ACCESSION NBR: 9503010391 DOC. DATE: 95/02/20 NOTARIZED: NO DOCKET #
 FACIL: 50-250 Turkey Point Plant, Unit 3, Florida Power and Light C 05000250
 AUTH. NAME AUTHOR AFFILIATION
 PLUNKETT, T.F. Florida Power & Light Co.
 RECIP. NAME RECIPIENT AFFILIATION
 Document Control Branch (Document Control Desk)

SUBJECT: Forwards relief request for Turkey Point Unit 3 Class 1 & Class 2 pressure retaining similar & dissimilar metal welds in vessels & piping.

Re: Turkey Point Unit 3
Docket Nos. 50-250
Impractical Inservice Inspection
Requirements - Second Ten Year
Interval Program Summary Report

Relief Request No. 1

FIGURE 1

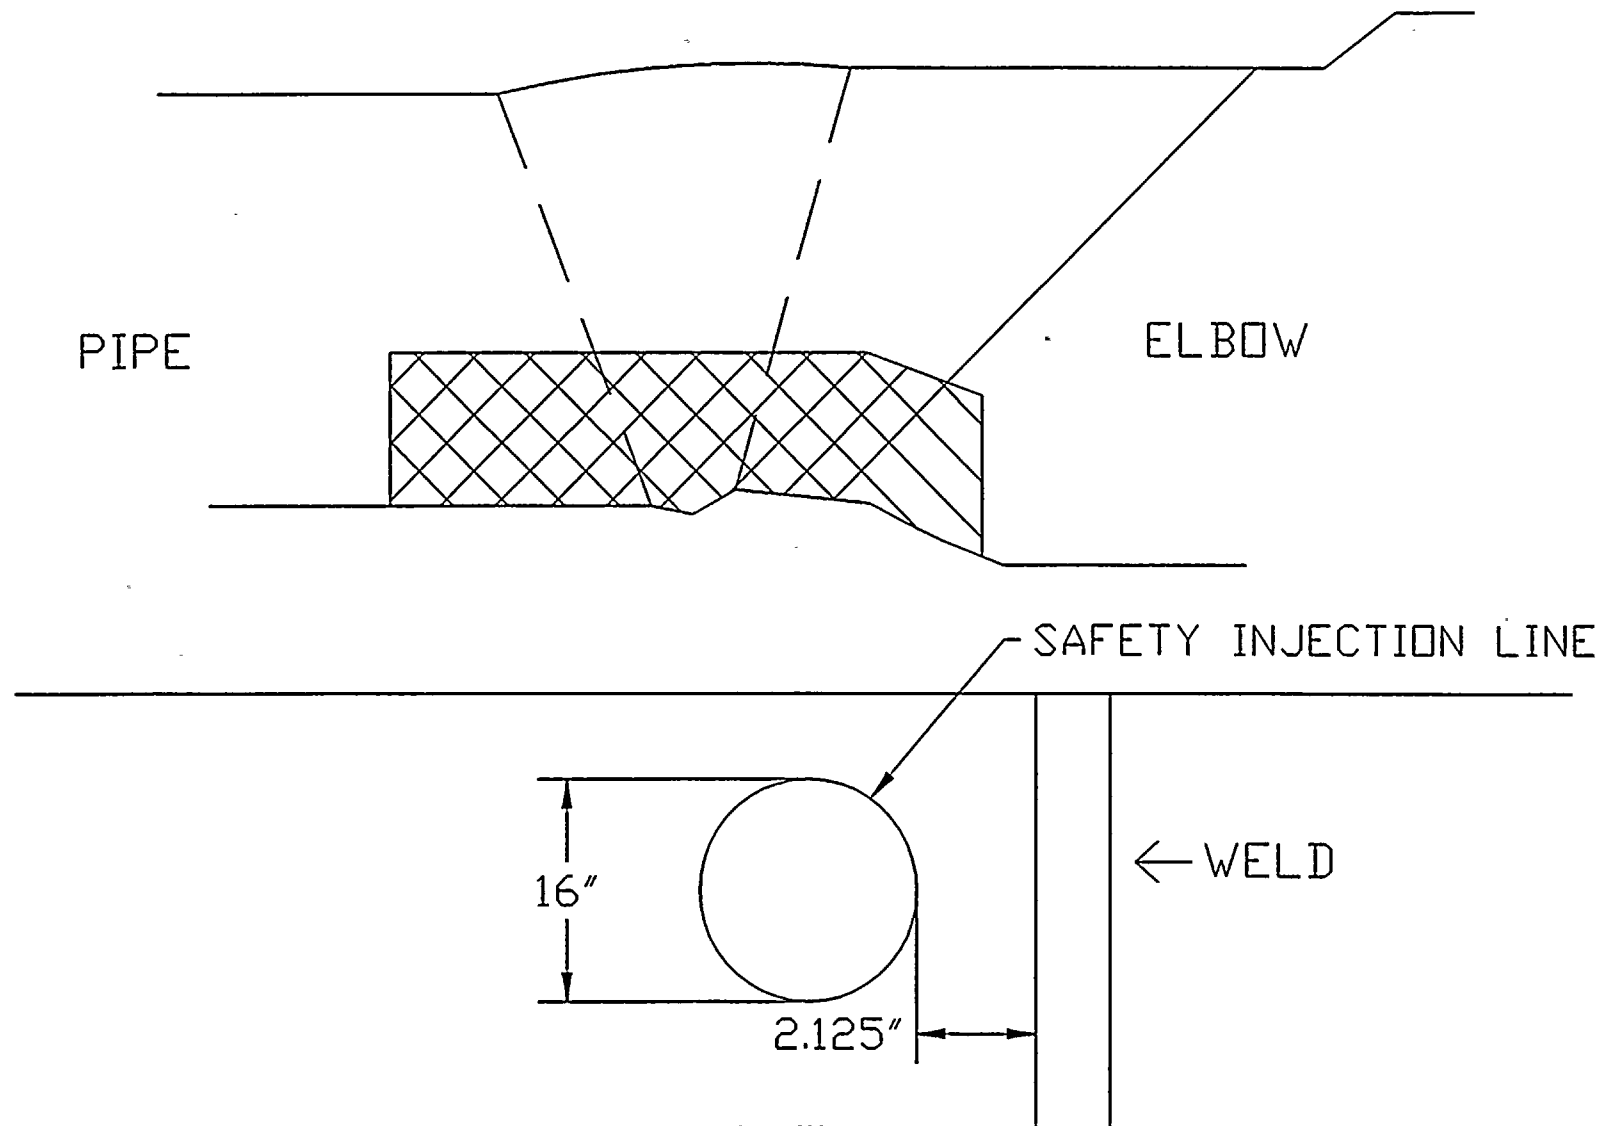
Catgy/ Item No.	Year of Exam	Zone	Item	NDE Tech	Angle and Technique			Configuration or Limitations	Fig. No.	Comments / % Coverage
					1/2 V	Full V	1 1/2 V			
B-J B9.11	85	3-010	31"-RCS-1302-8	UT	45	-	-	Elbow configuration limits exam	1	100% from Pipe Side, 82% from Elbow Side
B-J B9.11	85	3-011	29"-RCS-1305-3	UT	45	-	-	Branch Connection Limit 18", Elbow configuration limits exam	2	93% from Pipe Side, 69% from Elbow Side
B-F B5.70	85	3-011	29"-RCS-1305-4	UT	45	-	-	Nozzle to Elbow	3	43% from Elbow Side, 2% from Nozzle Side
C-F C5.21	85	3-101	26"-MSB-2305-15	MT	-	-	-	Floor limits exam	4	85% Surface Coverage Achieved
C-F C5.21	85	3-103	6"-BDA-2301-2	UT	-	-	45	Pipe to Valve	5	100% from Pipe Side, 50% from Valve Side
C-F C5.21	85	3-103	6"-BDA-2301-8	UT	-	-	45	Tee to Pipe	5	100% from Pipe Side, 50% from Tee Side
C-F C5.11	85	3-106	6"-BDA-2304-26	MT	-	-	-	Floor limits exam	4	74% Surface Coverage Achieved

FIGURE 8

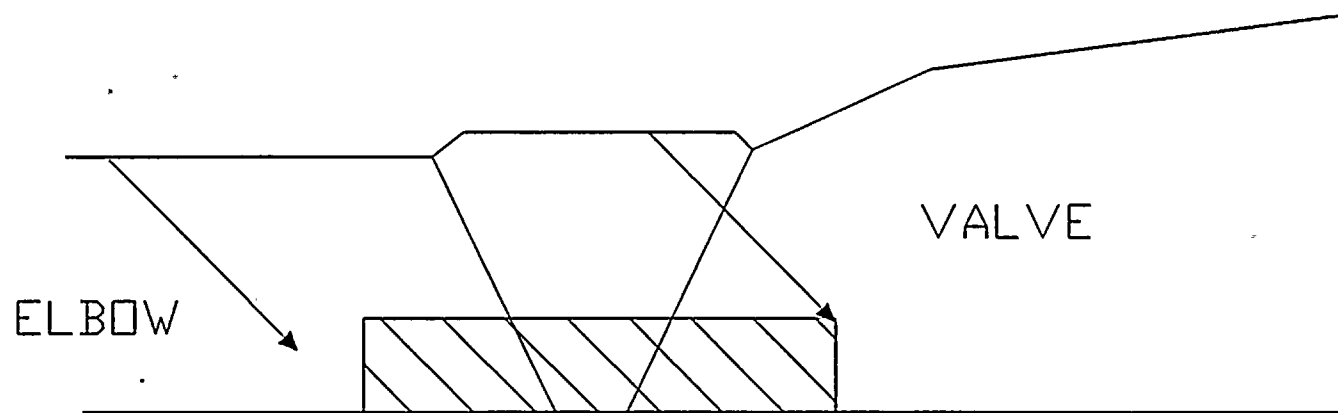
B-D B3.140	90	3-003	3-SGB-I-IRS	UT	45	-	-	Welded on pads, support, and configuration	11	70% Coverage Achieved in Two Directions
B-D B3.140	90	3-003	3-SGB-O-IRS	UT	45	-	-	Welded on pads, support, and configuration	11	70% Coverage Achieved Two Directions
B-D B3.120	87	3-006	3-SRGN-01-IR	UT	30 60	- -	- -	heater penetrations limited the exam area	6	55% coverage from 2 directions
B-J B9.21	87	3-043	2"-SI-1305-4	PT	-	-	-	Component Support limited the exam area	7	87% Surface Coverage Achieved
C-F C5.21	87	3-081	10"-SI-2304-3	UT	45	-	-	Valve MOV-3-744A to pipe	8	100% from the pipe side, 0% from valve side

B-J B9.11	90	3-038	8"-RHR-1302-1	UT	45 60	- -	- -	Valve 3-876B to pipe	15	100% from Pipe Side, 0% from Valve Side
B-J B9.11	90	3-039	10"-SI-1303-11	UT	45 60	- -	- -	Elbow to valve 3- 875C	8	100% from Elbow side, 0% from Valve side
C-F C5.21	90	3-079	10"-SI-2302-5	UT	45 60	- -	- -	Valve 3-865B to pipe	15	100% from pipe, 0% from valve, examination not required during third interval
C-F C5.21	90	3-079	10"-SI-2302-6	UT	45 60	- -	- -	Pipe to valve 3-875E	15	100% from pipe, 0% from valve, examination not required during third interval
C-F C5.21	90	3-081	10"-SI-2305-3	UT	45 60	- -	- -	Valve MOV-3-744B to pipe	15	100% from pipe, 0% from valve

VALVE SURFACE IS IN
THE AS-CAST CONDITION.
NOT CONDUCTIVE TO PROPER
EXAMINATION.

FIGURE 9

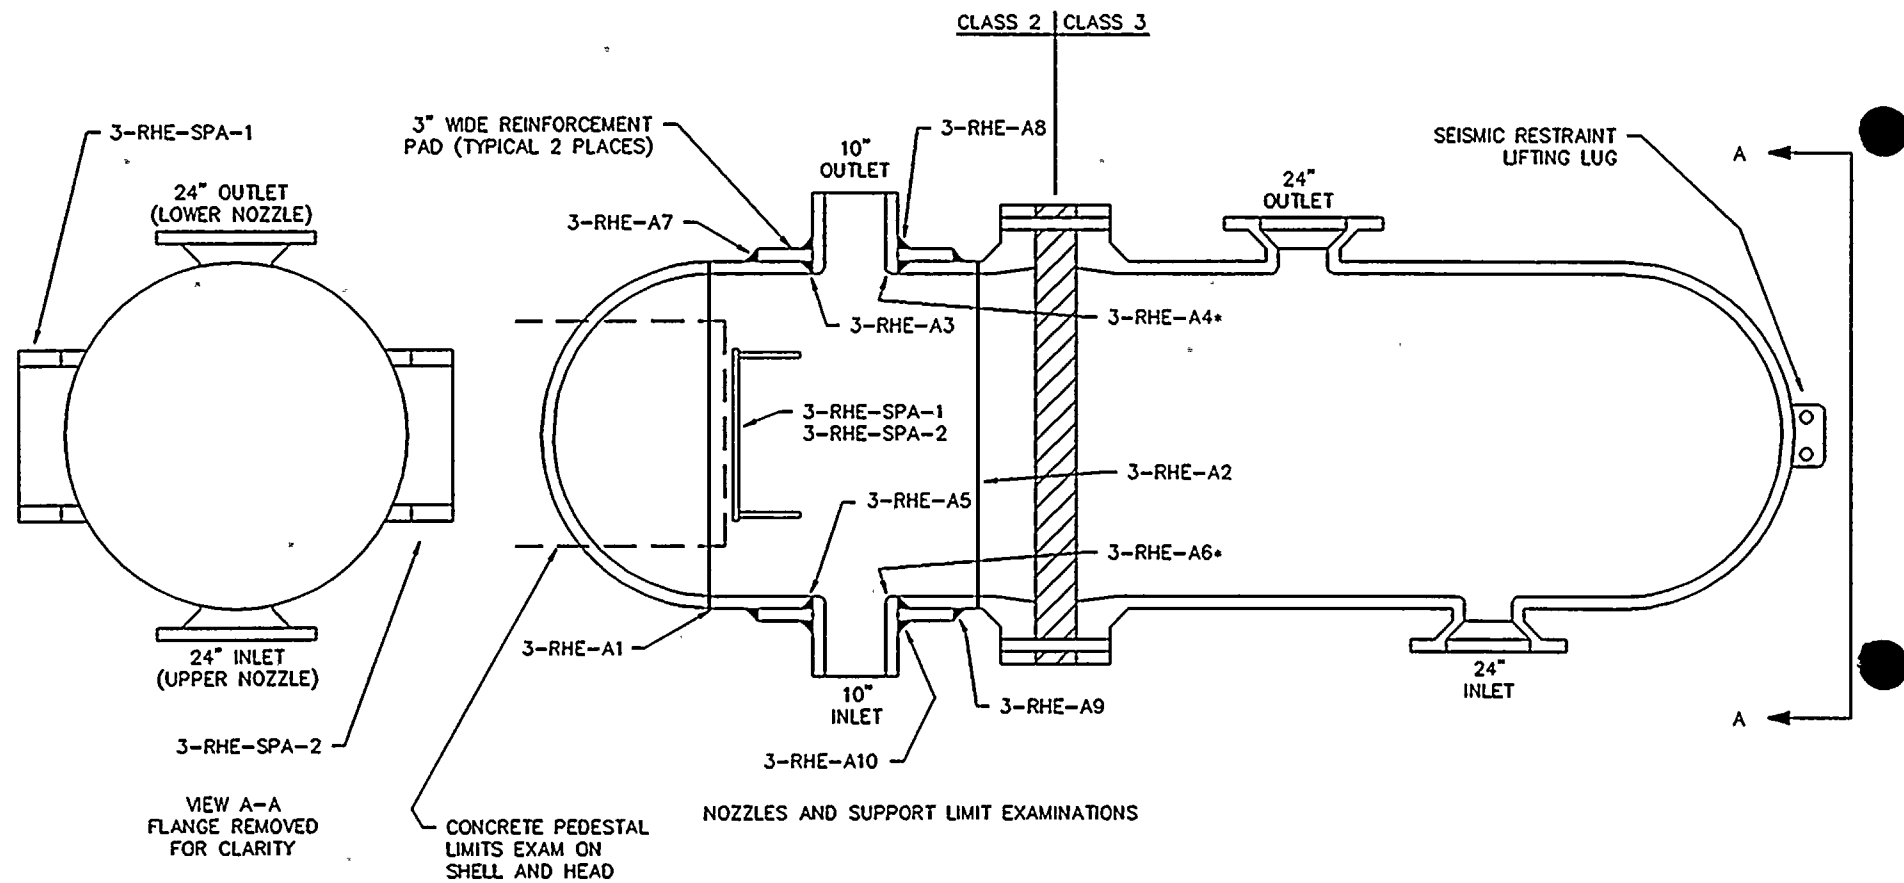
Catgy/ Item No.	Year of Exam	Zone	Item	NDE Tech	Angle and Technique			Configuration or Limitations	Fig. No.	Comments / % Coverage
					1/2 V	Full V	1 1/2 V			
C-F C5.21	87	3-089	8"-SI-2310-24	UT	-	-	45	Pipe to Valve 3-876E	9	100% from the pipe side, 50% from the valve side
C-A C1.20	87	3-115	3-RHE-A1	UT	45	-	-	Inlet and outlet nozzles and component supports limit exam	10	27% from the shell side, 80% from the head side
B-D B3.140	90	3-003	3-SGA-I-IRS	UT	45	-	-	Welded on pads, support, and configuration	11	70% Coverage Achieved in Two Directions
B-D B3.140	90	3-003	3-SGA-O-IRS	UT	45	-	-	Welded on pads, support, and configuration	11	70% Coverage Achieved Two Directions
B-D B3.120	90	3-006	SP-03-I-IR	UT	30 60	- -	- -	Configuration of Spray Inner Radius limits exam	12	70% Coverage Achieved from 2 Directions, 15% Coverage 1 Direction, 15% Not Covered
B-D B3.120	90	3-006	RV-03-551C-IR	UT	60	-	-	Interference from Insulation Ring	12	40% Coverage Achieved in Two Directions

VALVE SURFACE IS IN
THE AS-CAST CONDITION.
NOT CONDUCTIVE TO PROPER
EXAMINATION.

FIGURE 10

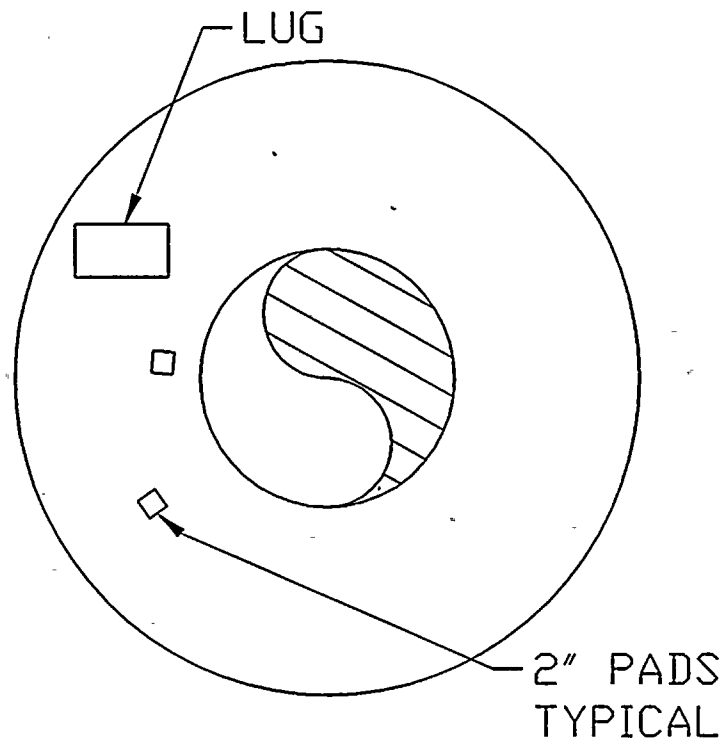
Catgy/ Item No.	Year of Exam	Zone	Item	NDE Tech	Angle and Technique			Configuration or Limitations	Fig. No.	Comments / % Coverage
					1/2 V	Full V	1 1/2 V			
B-J B9.11	91	3-021	4"-RC-1305-19	UT	- 60	- -	45 -	Pipe to tee	18	100% from pipe side, 60% from tee side
B-J B9.11	91	3-022	4"-RC-1306-7	UT	- 60	- -	45 -	Tee to reducer	19 22	100% from reducer side, 65% from tee side
B-J B9.11	91	3-037	8"-RHR-1301-1	UT	45 60	- -	- -	Tee to elbow	20	100% from elbow side, 31% from tee side
B-J B9.11	91	3-038	10"-SI-1302-4	UT	45 60	- -	- -	Elbow to valve 3- 875B, sweepolet limits coverage	15	85% from elbow side, 25% from valve side
C-F C5.21	91	3-105	6"-BDC-2303-1	UT	- 60	- -	45 -	Reducer to valve SGB-3-005	17	85% from reducer side, 72% from valve side
C-F C5.21	91	3-105	6"-BDC-2303-5	UT	- 60	- -	45 -	Reducer to valve SGB-3-006	17	72% from reducer side, 66% from valve side
C-C C3.10	92	3-115	3-RHE-SPA-1 3-RHE-SPA-2	PT	-	-	-	Support attachment, no exam on bottom due to concrete pedestal	10	No exam on bottom of integral attachment due to permanent support structure

FIGURE 11

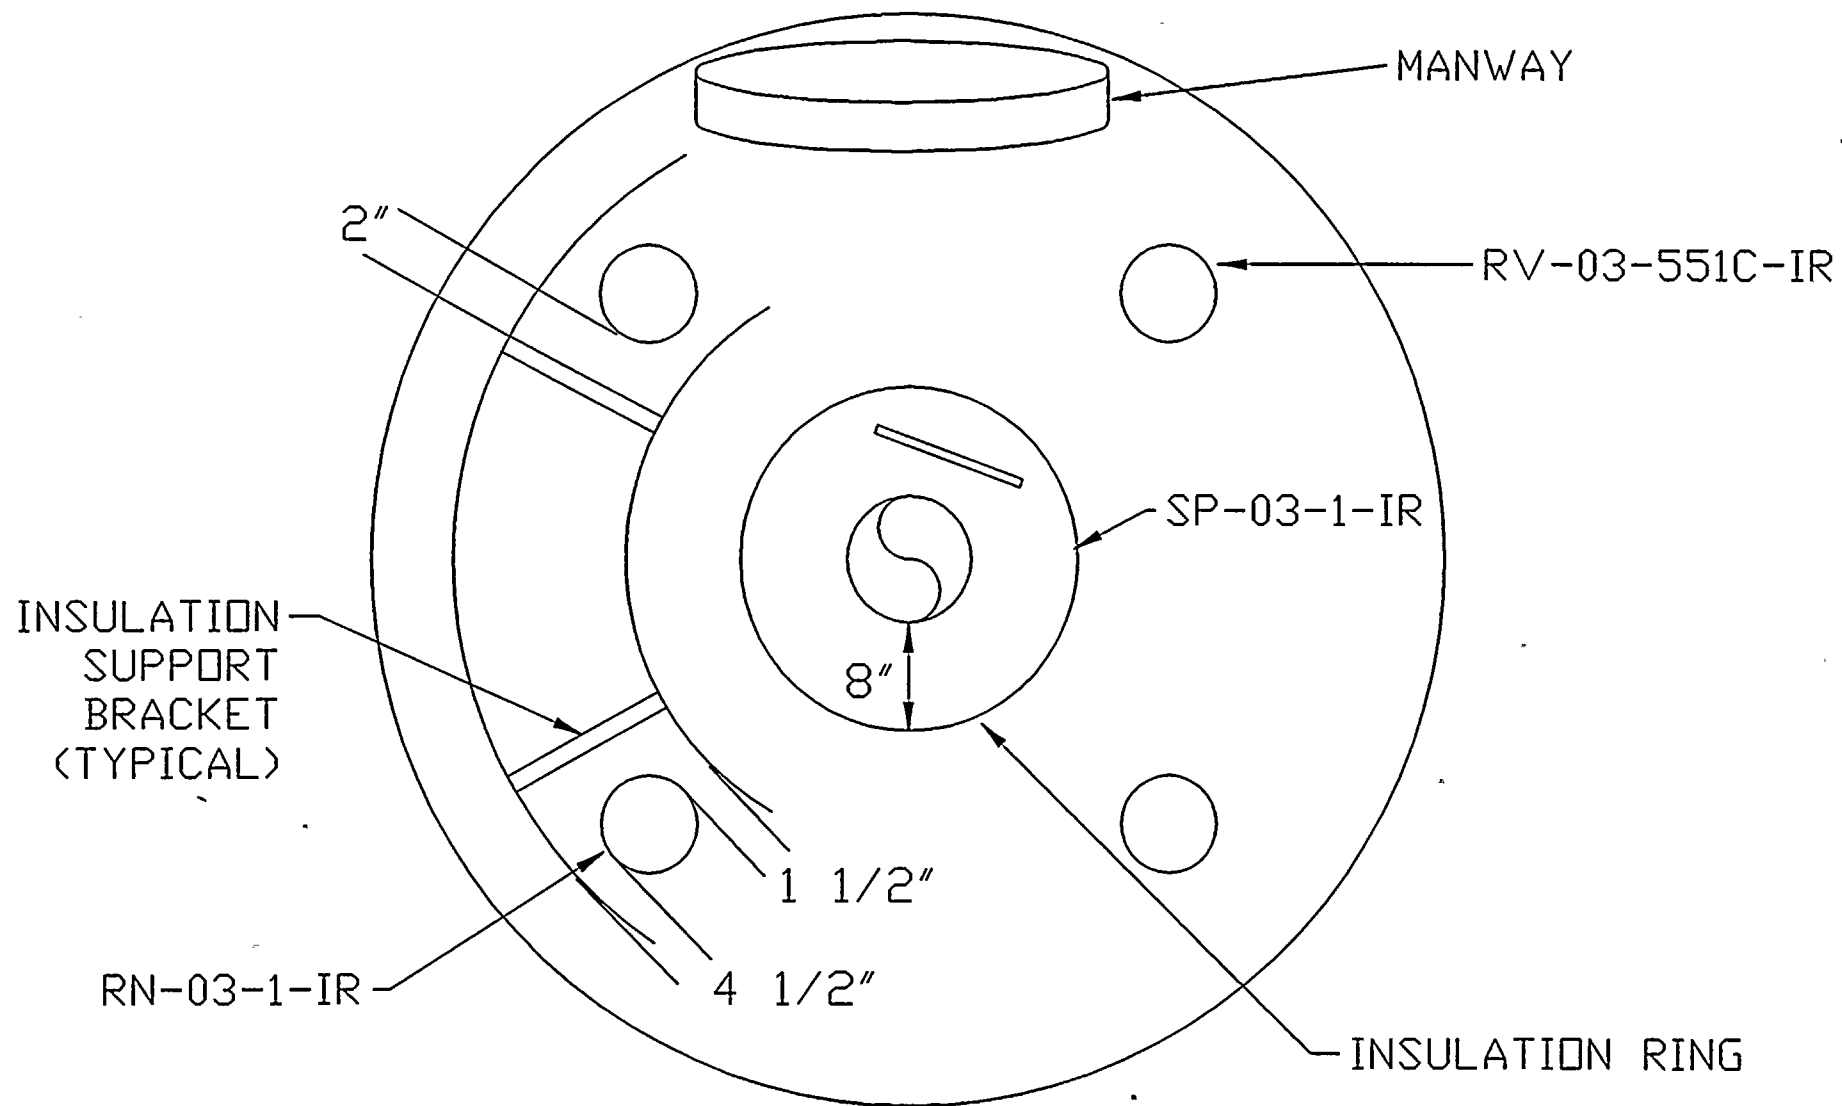
C-A C1.10	92	3-115	3-RHE-A2 ,	UT	45 60	- -	- -	Shell to Flange configuration, Branch Connections and Welded Support Pads limit exam	16	82% from Shell Side, 0% From Flange Side
B-D B3.140	92	3-005	3-SGC-I-IRS	UT	45	-	-	Welded on pads, support, and configuration	11	70% Coverage in 2 Directions
B-D B3.140	92	3-005	3-SGC-O-IRS	UT	45	-	-	Welded on pads, support, and configuration	11	70% Coverage in 2 Directions

FIGURE 13

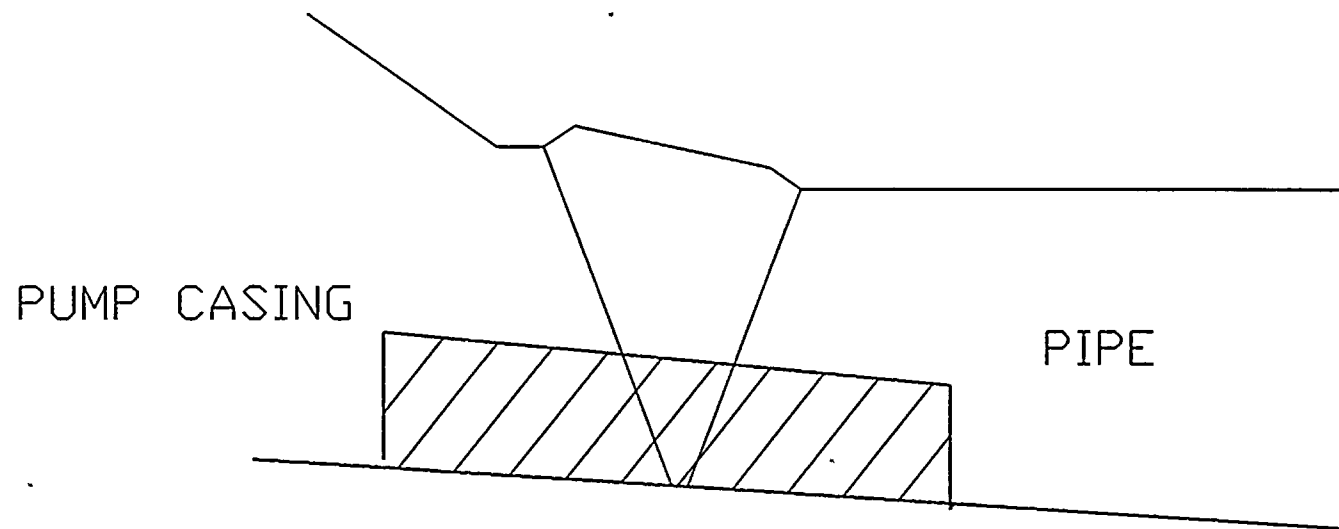
B-D B3.120	90	3-006	RN-03-1-IR	UT	60	-	-	Interference from Insulation Ring	12	40% Coverage Achieved in Two Directions
B-F B5.70	90	3-007	31"-RCS-1301-5	UT	45	-	-	Steam generator nozzle to elbow	13	75% from Elbow Side, 0% from Nozzle Side
B-F B5.70	90	3-010	31"-RCS-1302-5	UT	45	-	-	Steam generator nozzle to elbow	13	75% from Elbow Side, 0% from Nozzle Side
B-F B5.70	90	3-008	29"-RCS-1304-4	UT	45	-	-	Elbow to Nozzle	13	100% from Elbow Side, 0% from Nozzle Side
B-J B9.11	90	3-009	27.5"-RCS-1307-11	UT	45	-	-	Pump casing to pipe	13	55% from Pipe Side, 0% from Pump Side

B-J B9.11	91	3-007	31"-RCS-1301-10	UT	45	-	-	Elbow to pump casing	13	75% from elbow side, 0% from pump side
B-J B9.11	91	3-010	31"-RCS-1302-10	UT	45	-	-	Elbow to pump casing	13	75% from elbow side, 0% from pump side
B-F B5.70	91	3-013	31"-RCS-1303-5	UT	45	-	-	Steam Generator nozzle to elbow	13	75% coverage from elbow side, 0% coverage from nozzle side
B-F B5.70	91	3-014	29"-RCS-1308-4	UT	45	-	-	Elbow to steam generator nozzle	13	100% from elbow side, 0% from nozzle side
B-J B9.11	91	3-020	4"-RC-1304-18	UT	- 60	- -	45 -	Elbow to tee	18	70% from elbow side, 70% from tee side

FIGURE 14

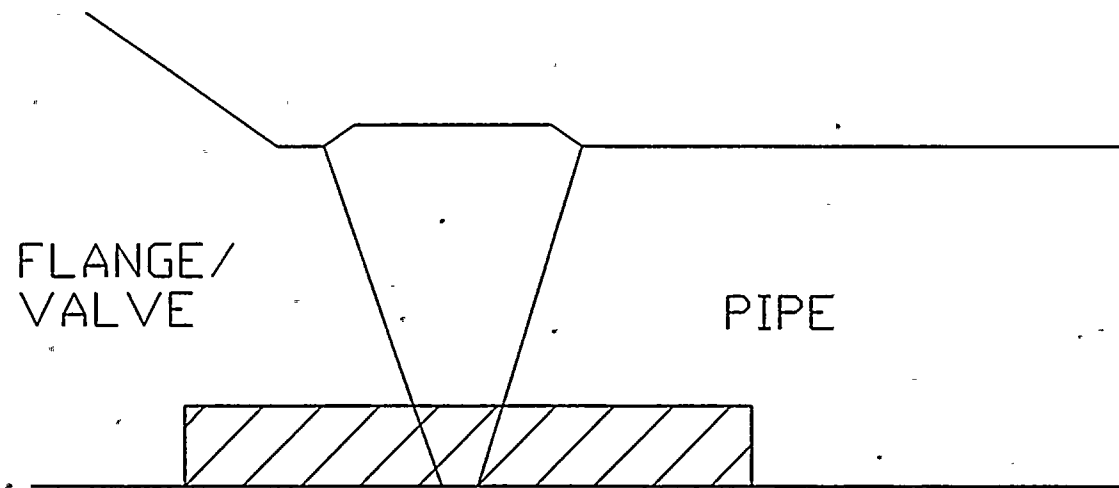
Catgy/ Item No.	Year of Exam	Zone	Item	NDE Tech	Angle and Technique			Configuration or Limitations	Fig. No.	Comments / % Coverage
					1/2 V	Full V	1 1/2 V			
B-J B9.11	90	3-012	27.5"-RCS-1306-11	UT	45	-	-	Pump casing to pipe	14	100% from Pipe Side, 0% from Pump Side
B-J B9.11	90	3-016	12"-RC-1301-1	UT	45 60	- -	- -	Branch connection to pipe	15	100% from Pipe side, 0% from Nozzle side
B-F B5.40	90	3-017	4"-RC-1301-1A	UT	45	-	-	Nozzle to safe-end	23	50% from Safe End Side, 50% from Nozzle Side
B-F B5.40	90	3-022	4"-RC-1306-1A	UT	45	-	-	Nozzle to safe-end	23	50% from Safe End Side, 50% from Nozzle Side
B-J B9.11	90	3-036	14"-RHR-1301-6	UT	45 60	- -	- -	Pipe to valve 3-750	15	100% from Pipe Side, 0% from Valve
B-J B9.11	90	3-037	8"-RHR-1301-3	UT	45 60	- -	- -	Elbow to valve 3- 876A	24	100% from Elbow side, 0% from Valve side
B-J B9.11	90	3-038	10"-SI-1302-1	UT	45 60	- -	- -	Elbow to branch connection	15	100% from Elbow Side, 0% from Branch Side
